DEVELOPMENT ASSESSMENT REPORT	
<b>Application No.</b>	MOD/2023/0237
<b>Address</b>	99 and 99A Louisa Road BIRCHGROVE
<b>Proposal</b>	Section 4.55(2) Modification of Development Consent DA/2022/0120 which approved alterations and additions to the existing dwelling, new garage with car stacker, swimming pool and associated works at 99 Louisa Road, seeking various internal and external changes, including fenestration and roof changes
<b>Date of Lodgement</b>	08 August 2023
<b>Applicant</b>	Bruce Han-Lee
<b>Owner</b>	Mrs Kristine L Jackson Mr Tibor PR Singer
<b>Number of Submissions</b>	Initial: Nil After Renotification: Nil
<b>Value of works</b>	\$850,000.00
<b>Reason for determination at Planning Panel</b>	FSR variation exceeds 10%
<b>Main Issues</b>	Non-compliance with FSR development standard
<b>Recommendation</b>	Approval
<b>Attachment A</b>	Recommended conditions of consent
<b>Attachment B</b>	Plans of proposed development

<b>Attachment C</b>	Current conditions of consent
<b>Attachment D</b>	Assessment report for DA/2022/0120

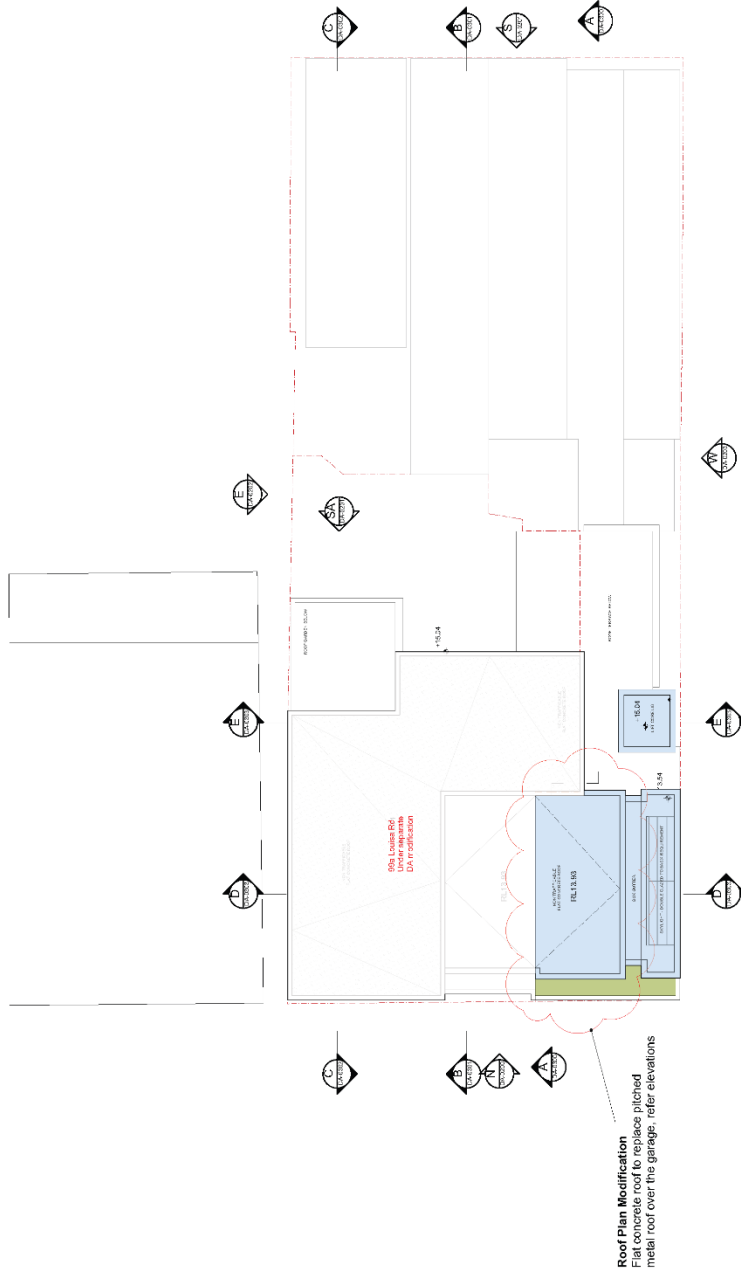
**Roof Plan Modification**  
 Flat concrete roof to replace pitched metal roof over the garage, refer elevations

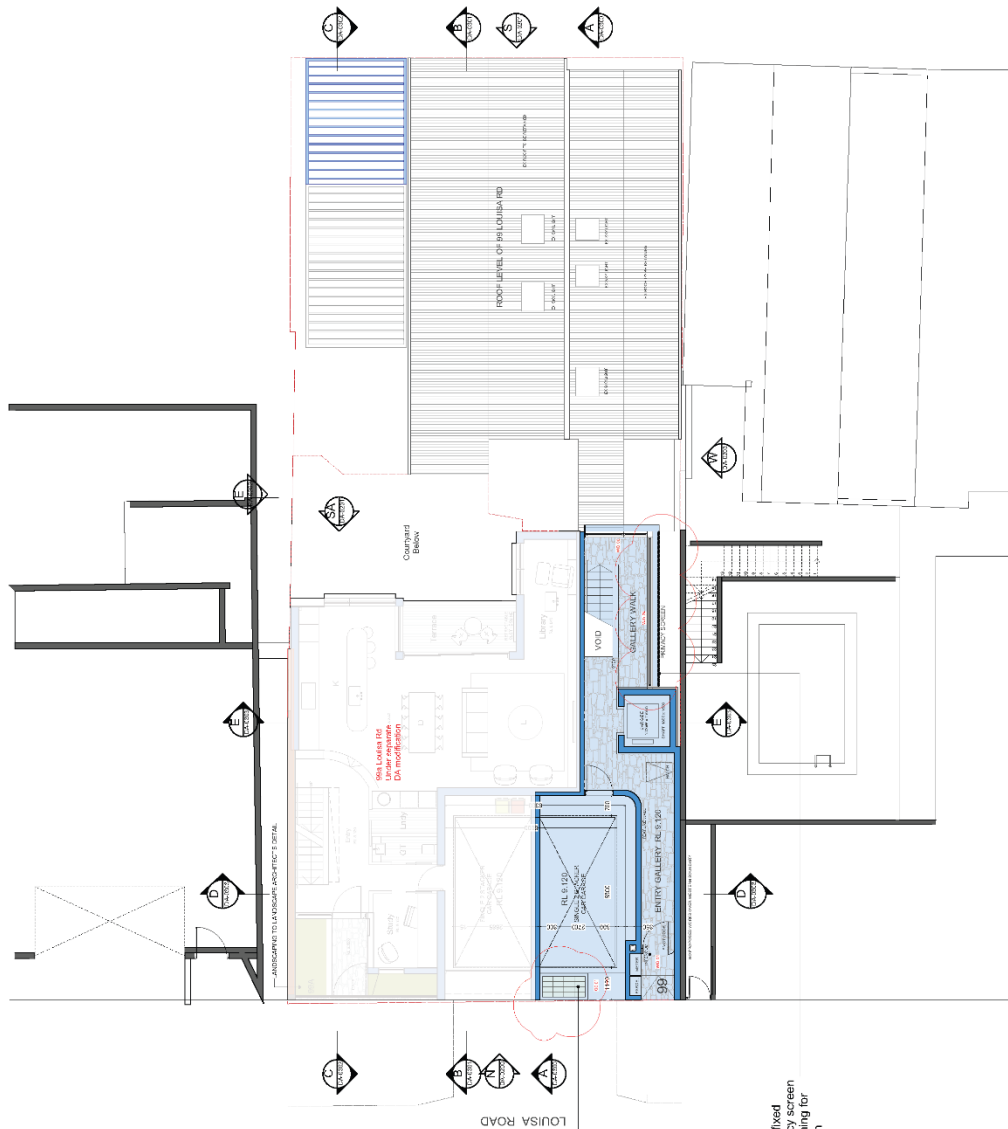
Modified satin anodised aluminium fixed battens vertical batten screen privacy screen to GF staircase glazing mixed batching for colour variation refer West Elevation

Drawing Number : DA Mod 05  
 Title : Upper Level Plan DA-2022/0120 Modification  
 Date : 09.10.23  
 Scale : 1:100 @ A2

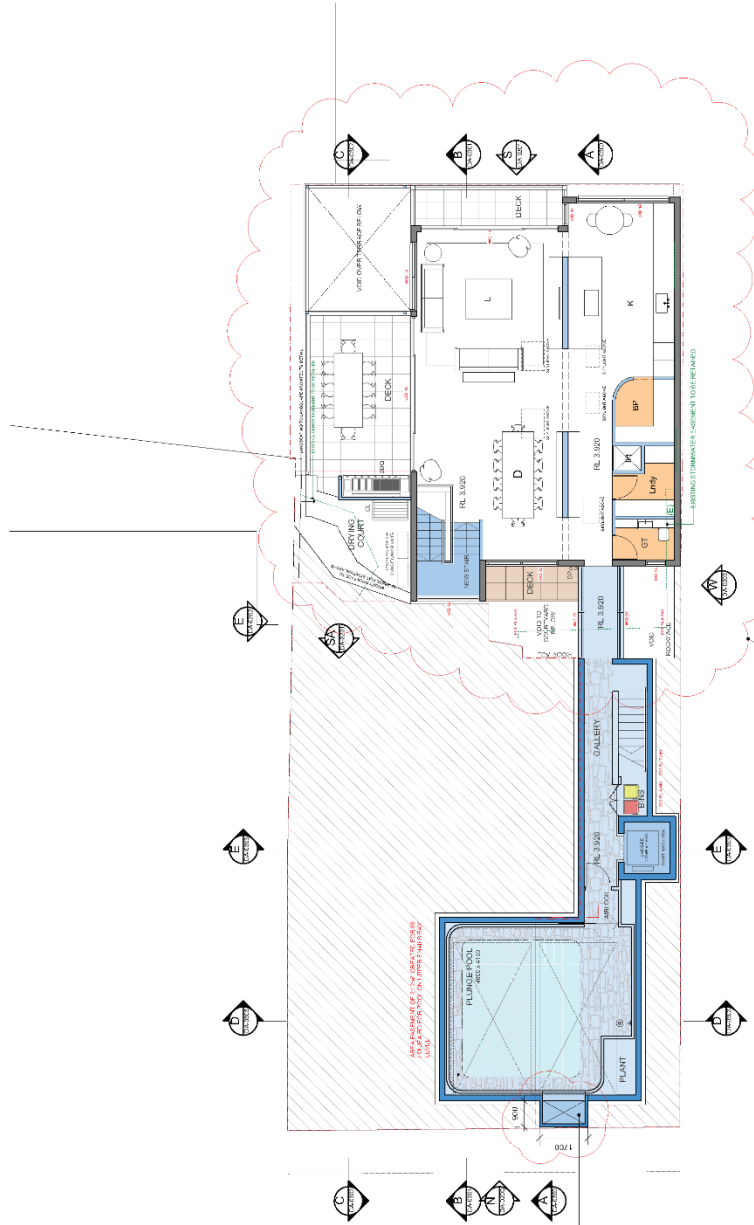
Daylight shaft providing indirect diffuse light to the plunge pool. Structural glass blocks in the driveway refer GF plan and Section AA

**Internal reconfiguration of the Upper Level Plan**  
 Reconfiguration of Dining, Kitchen and removal of the study  
 Inclusion of small northern deck from the dining space - 3.8m<sup>2</sup>  
 Inclusion of passenger lift connecting Upper to Lower Level  
 Reconfigured of guest WC, laundry and butler's pantry  
 Inclusion of satin anodised fixed batten privacy screens both sides of the bridge link  
 Inclusion of daylight shaft to the plunge pool

Drawing Number : DA Mod 07  
 Title - North Elevation - DA - 2022/0120 - Modification  
 Date : 09.10.23  
 Scale : 1:100 @ A2

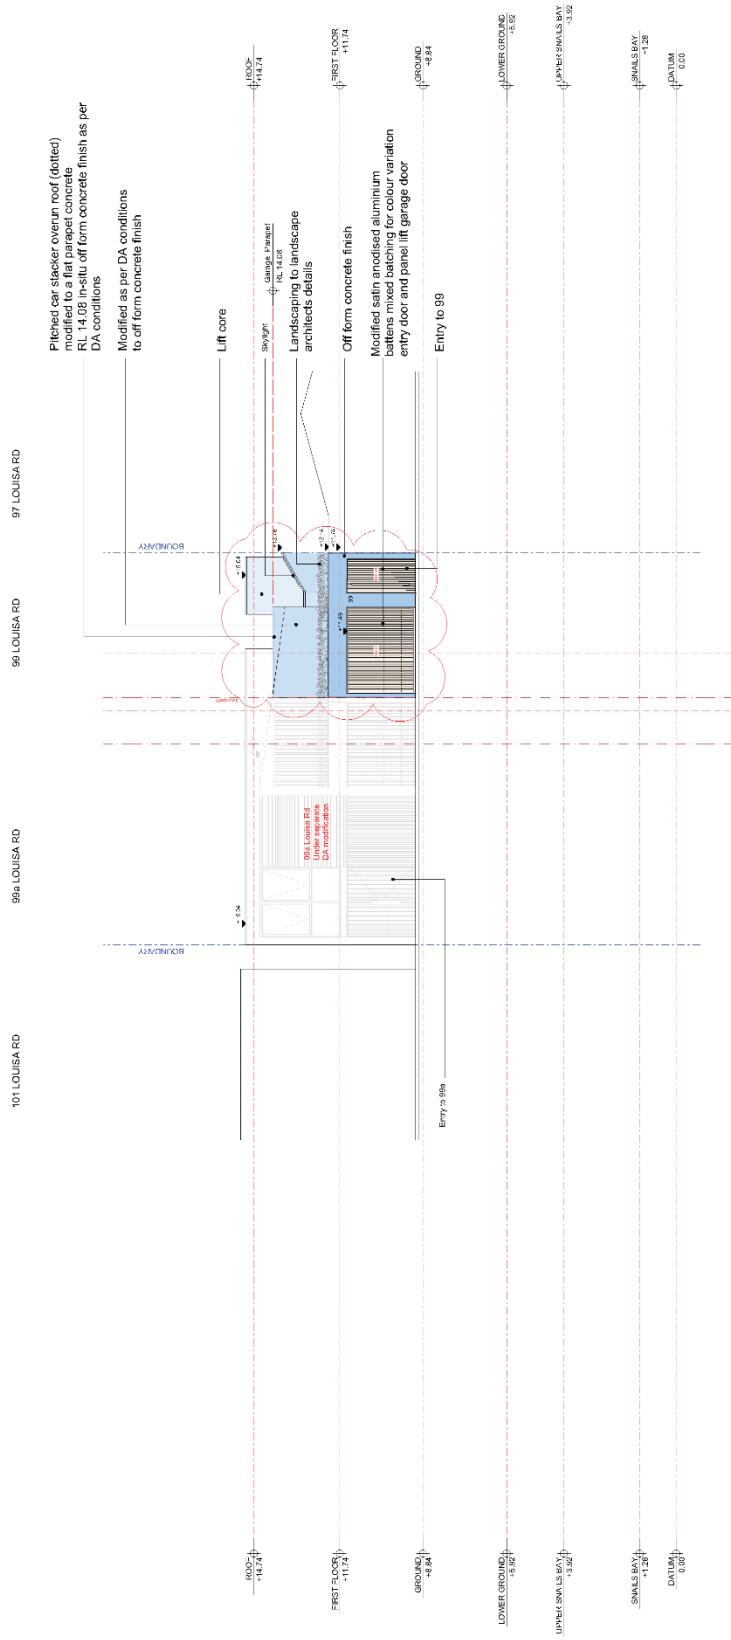
Pitched car stacker over run roof (dotted) modified to a flat parapet concrete RL 14.09 in-situ off form concrete finish as per DA conditions  
 Modified as per DA conditions to off form concrete finish

Figure A - Existing views from No. 95 Louisa Road's Living room

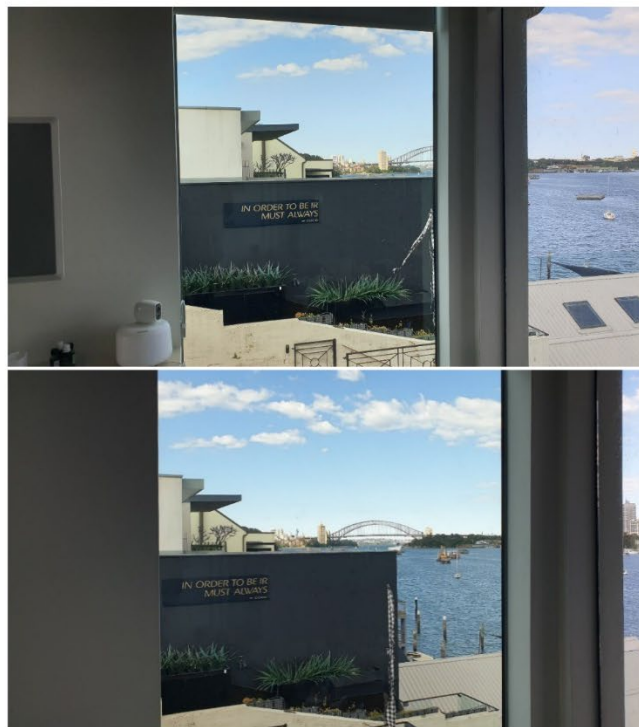
A submission was received regarding the neighbour's at 95 Louisa concerns of view loss of the Sydney Harbour Bridge and water views.

Council has considered the relevant steps in the assessment of reasonable view sharing. The images below indicate the existing views available from No. 95 Louisa Road's rear Balcony and the western window in the living. The below images were taken by Council during a site inspection of the property.

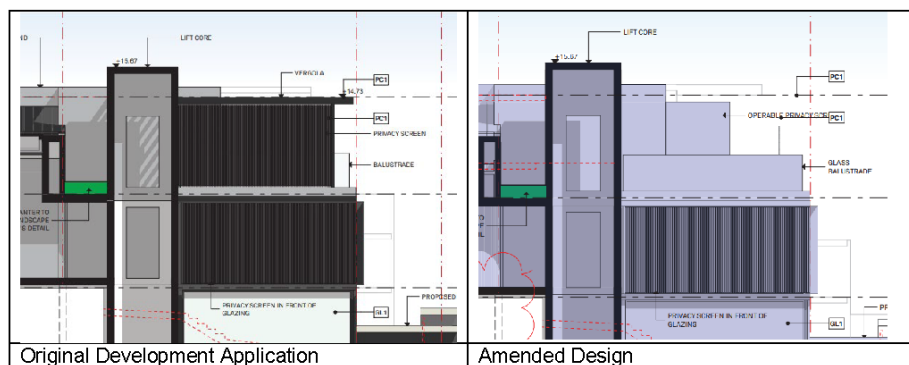
The submission lodged on behalf of the property of No. 95 Louisa Road suggests that a solution has been reached between the owners of 95 and 99 Louisa Road (refer to extract of submission below):

It was agreed between the parties that these view impacts would be fully ameliorated through specific design amendments to the design of upper storey including deletion of the pergola structure and blade privacy screen wall visible in the image below, and its replacement with a clear glass balustrade.
